**Report to the Future Melbourne (Planning) Committee**

**Ministerial Referral: TPM-2015-37  
71 to 87 City Road, Southbank**

**20 September 2016**

## PLANNING REPORT MINISTERIAL REFERRAL

**Recommended wind amelioration measures (Source Windtech Report October 2015)**

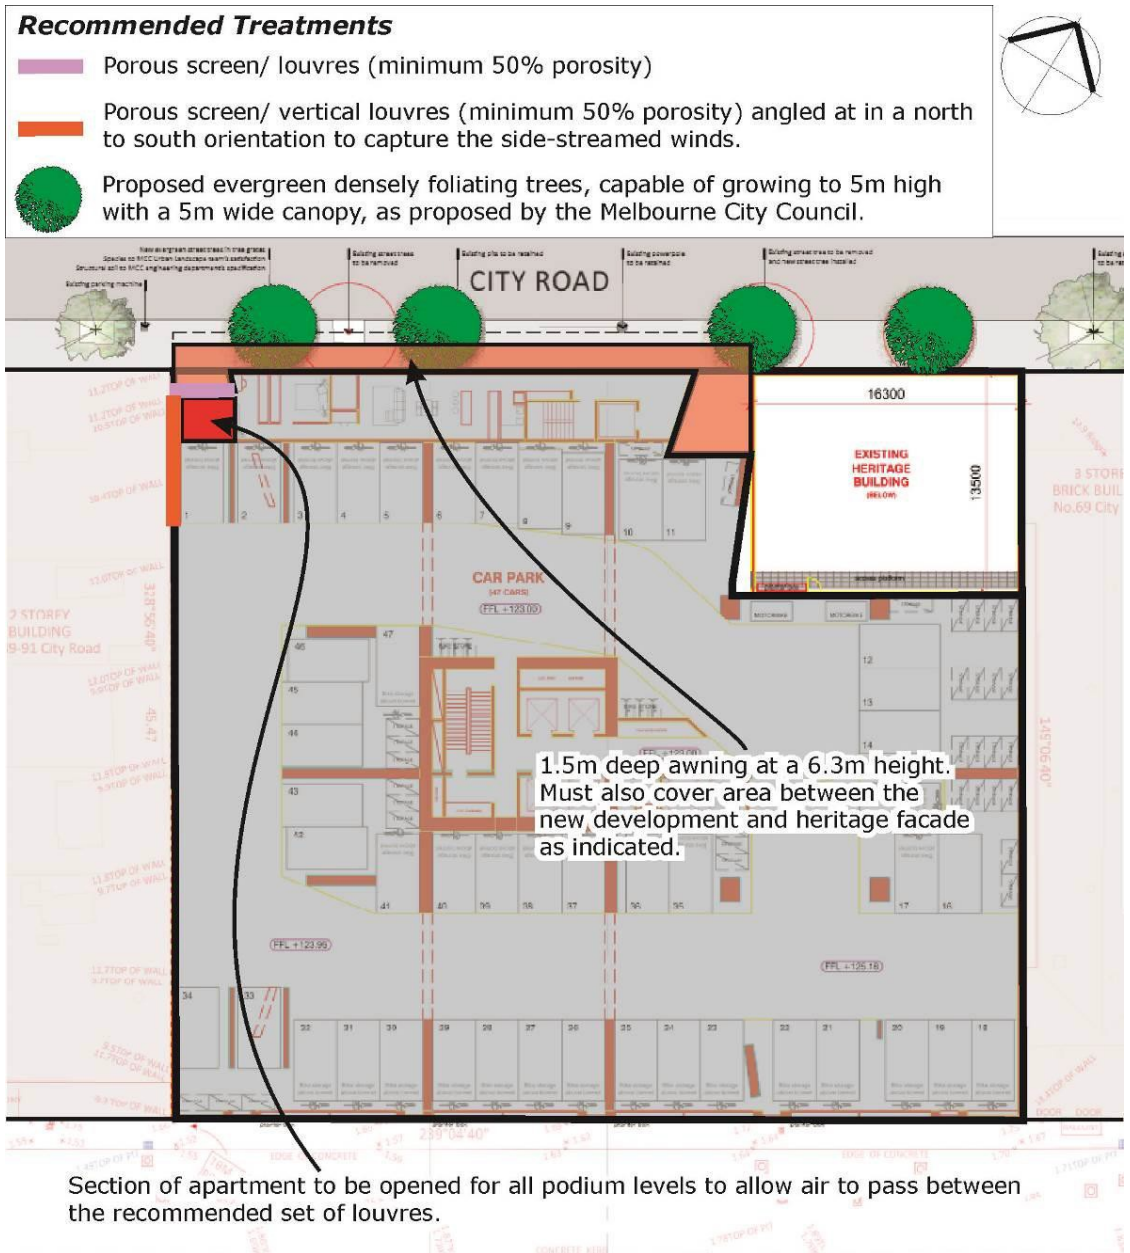
The submitted *Pedestrian Wind Environment Study* prepared by Windtech and dated 18 April 2016 states (in summery) that the existing wind condition along City Road exceed the walking criteria. For the development to maintain or improve this wind criteria, a 1.5 metre wide canopy is required on the City Road façade at 6.3 metres above ground level (excluding the heritage building) and including a cut in section of the new development (see diagram below). The area along Fawkner Street was found to meet the Melbourne Planning Scheme requirements for wind conditions. Several treatments were also recommended for private balconies and terraces within the proposed building.

Windtech confirmed in a letter dated 30 June 2016 that the above outcomes remain applicable to the revised plans received 14 July 2016.

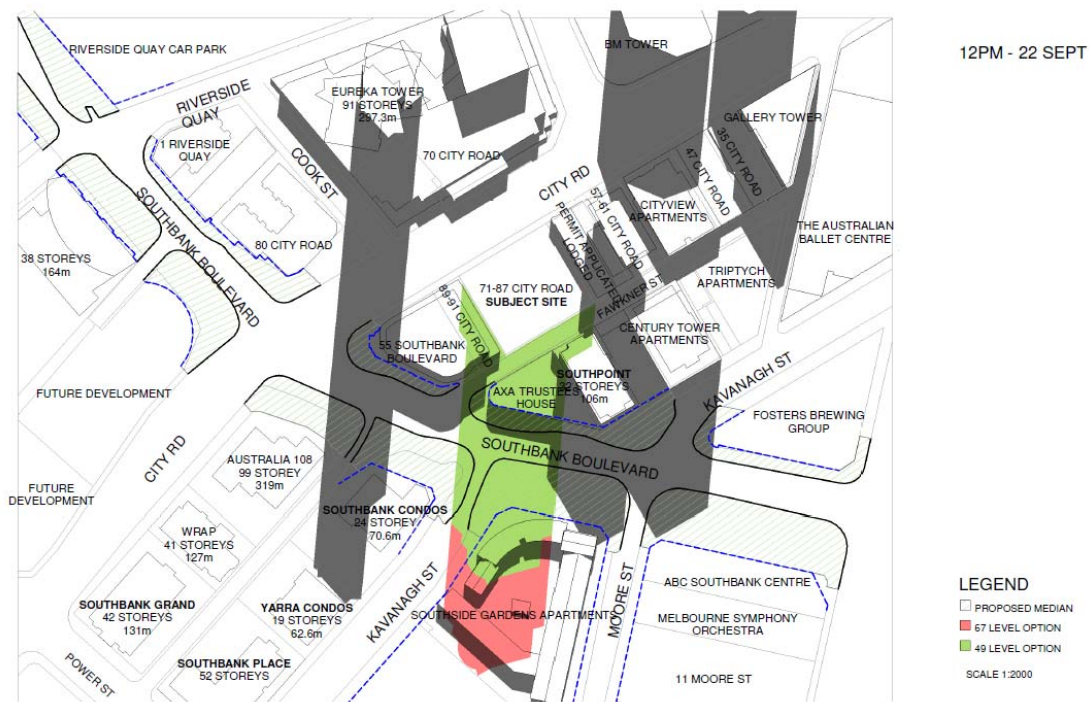
Clause 22.02 states that development, 'should not reduce the amenity of public spaces by casting any additional shadows on public parks and gardens, public squares, major pedestrian routes including streets and lanes (including all streets within the retail core of the Capital City Zone), and privately owned plazas accessible to the public between 11.00 am and 2.00 pm on 22 September'.

The surrounding public spaces are pedestrian routes including City Road, Southbank Boulevard, Fawkner Street and Kavanagh Street. The submitted shadow diagrams received by email dated 14 July 2016 indicate that there would be overshadowing of these streets between 11.00am and 2.00pm. In particular, Council's Urban Design team comments on the original proposal dated 1 February 2016 stated as follows:

'The proposal casts significant shadow onto the south footpath of Southbank Bld between about 9.30 and 3.30 on the solstice; new open space is

The revised plans received 14 July 2016 do not alleviate these concerns as the revised shadow diagrams received by email dated 14 July 2016 still indicate that the proposal would cast shadow onto the south footpath of Southbank Boulevard (see diagram below). This extent of overshadowing could be reduced with a building that complied with the building design requirements of DDO60 such as increased tower setbacks and separation.
